Request for Antenna change – PCB layout change V2 to V3 (2010 Wireless Guitar Controller – XBOX 360)

FCC ID:VFI95905805 IC:7196A-95905805

Blue = V3
Yellow = V2

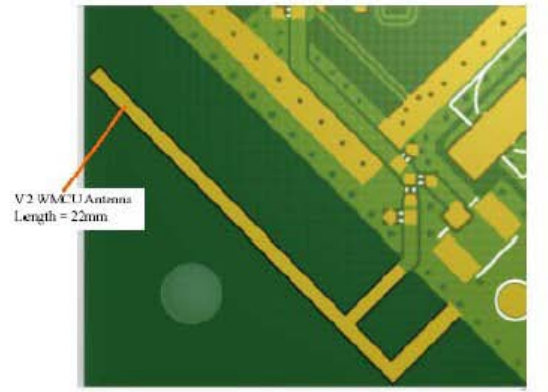
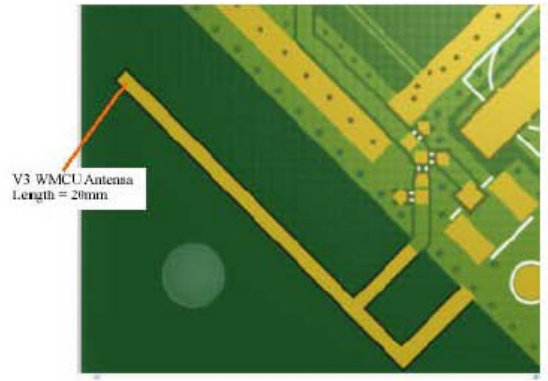
Antenna centering improvement is made by slight shortening of antennas tuned length. No impact on radiated power or emissions was detected in subsequent testing.
